## ADDENDUM NO. 04

MOUNTAIN TRANSIT MAINTENANCE FACILITY

**FOR THE**  
MOUNTAIN AREA REGIONAL TRANSIT AUTHORITY (MARTA)

RCA Project No. 5-08-01

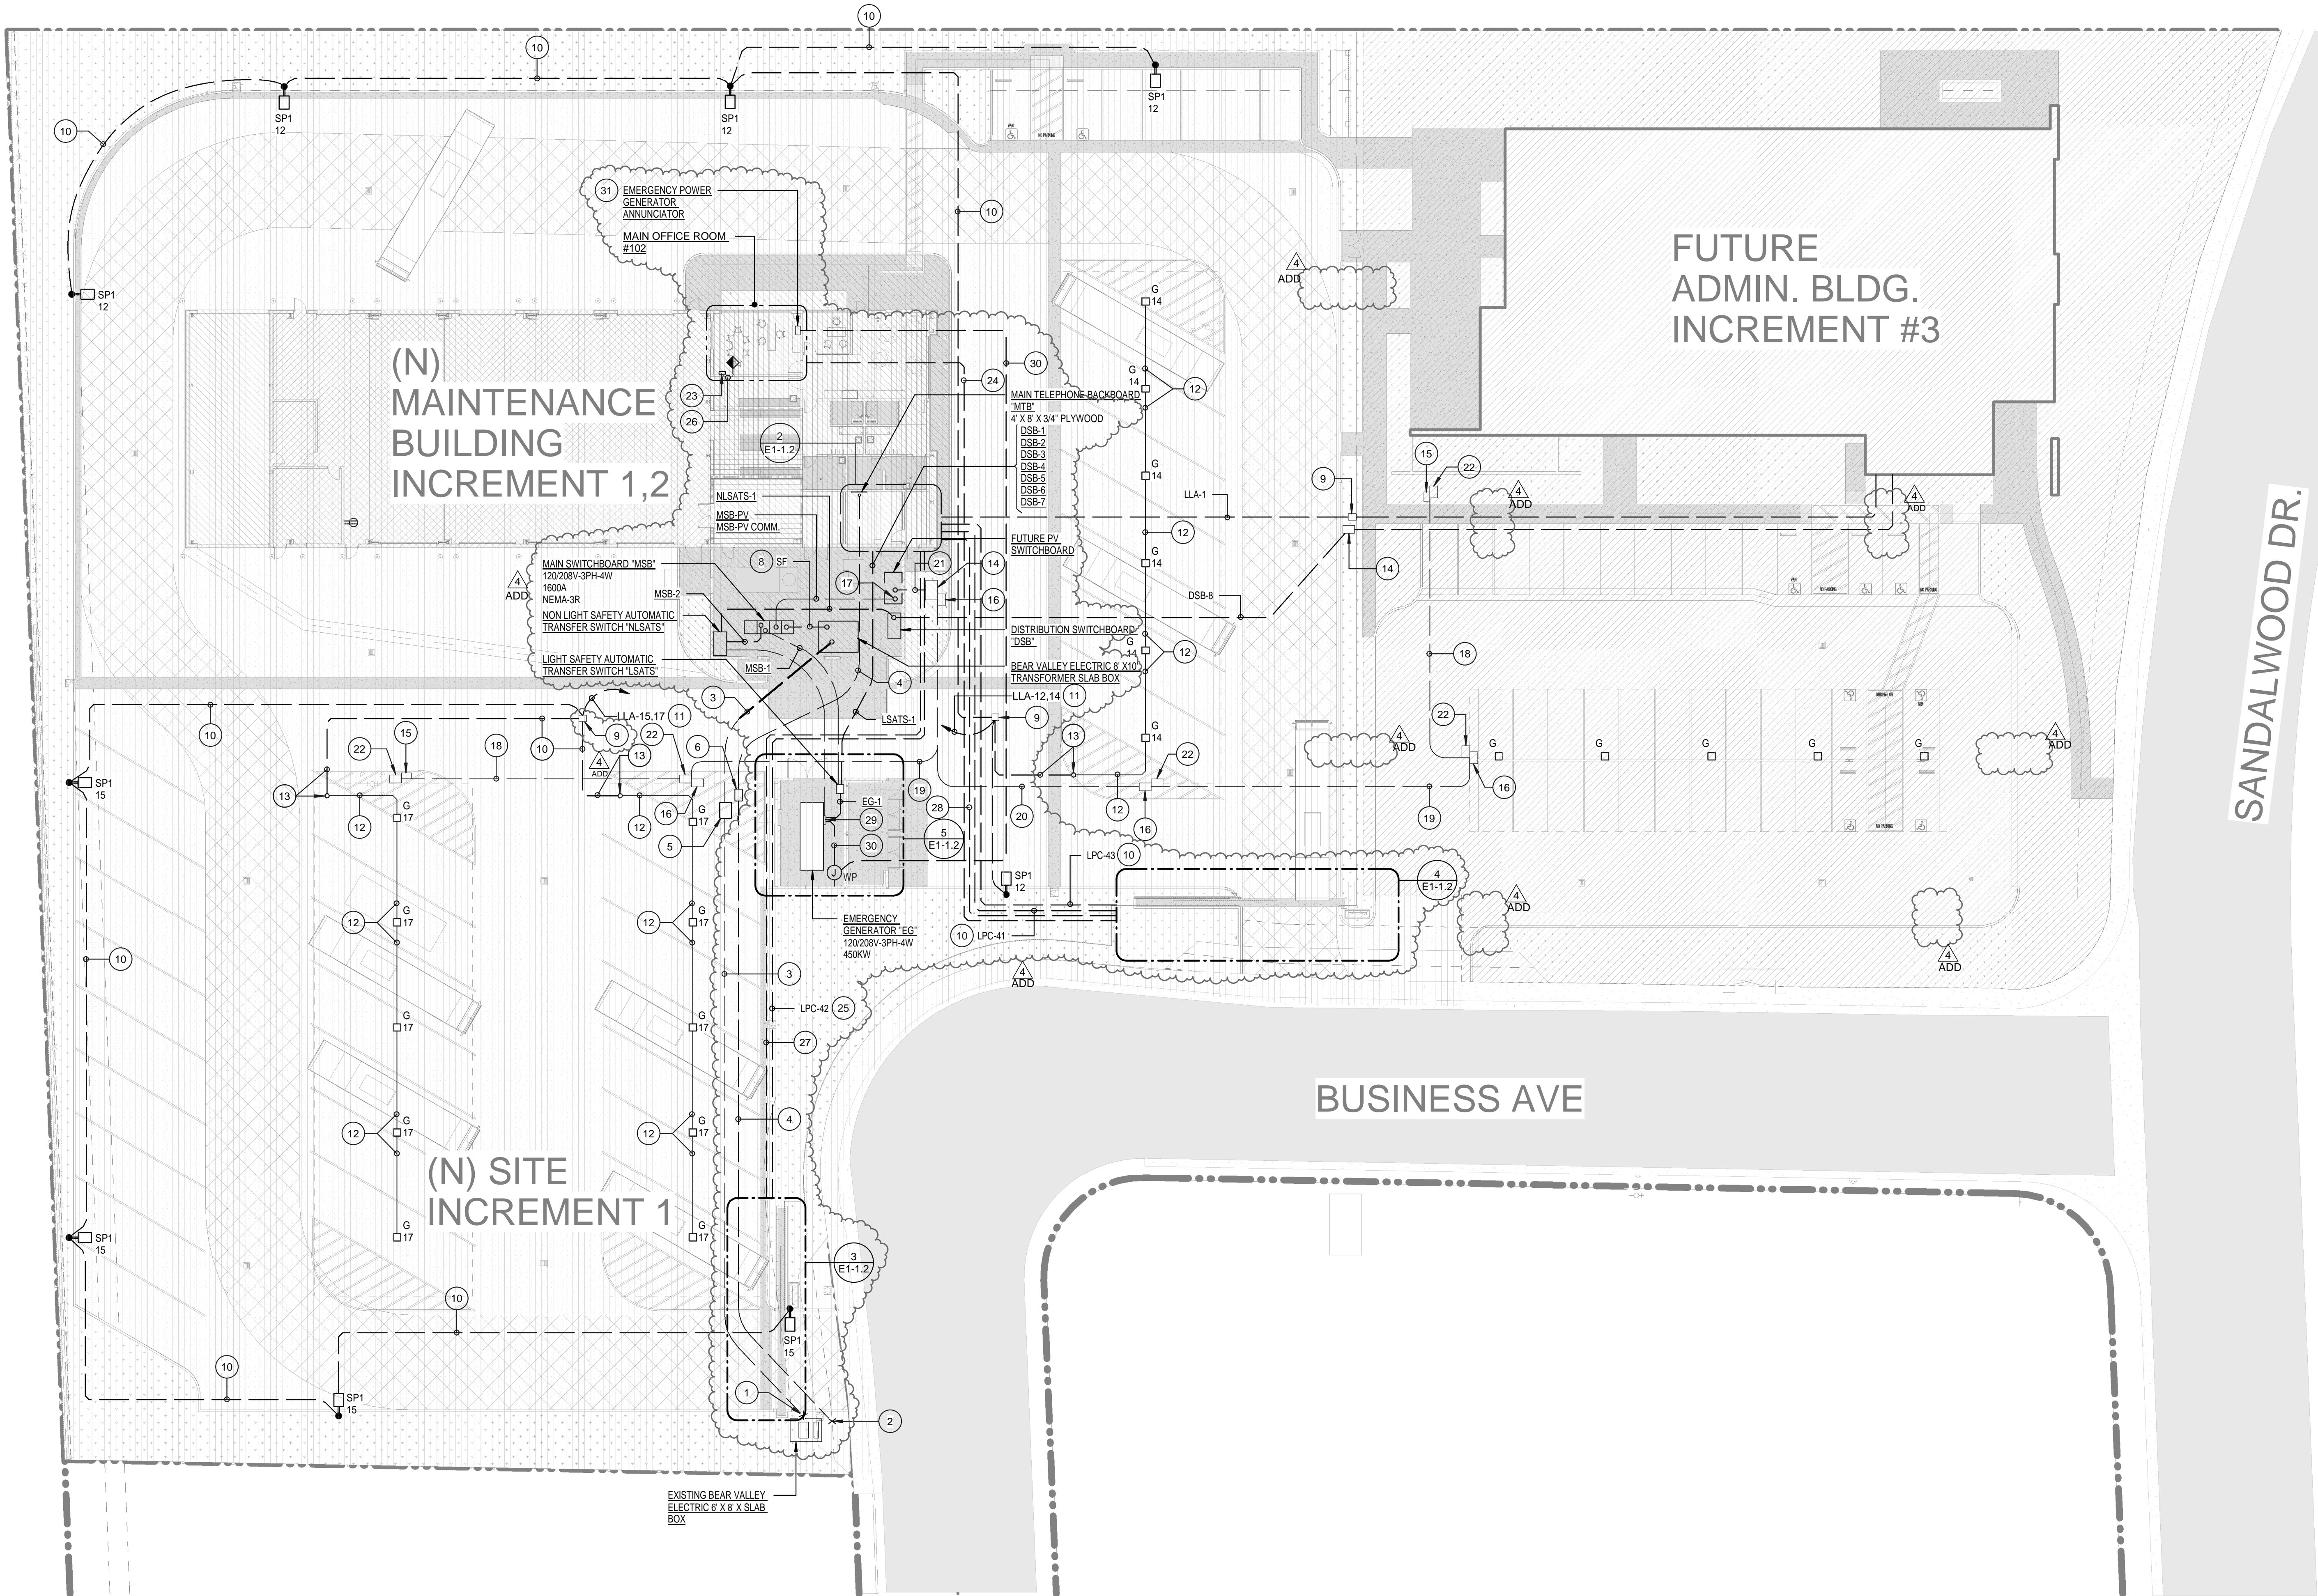
- Item No. 4.44 Reference Sheet ES-1.1 – SITE ELECTRICAL PLAN
- 4.44.1 Replace Sheet ES-1.1 and revise per clouded areas listed below:
    - a) Revised Site Electrical Plan per clouded areas

- b) Revised Plan Notes per clouded areas.
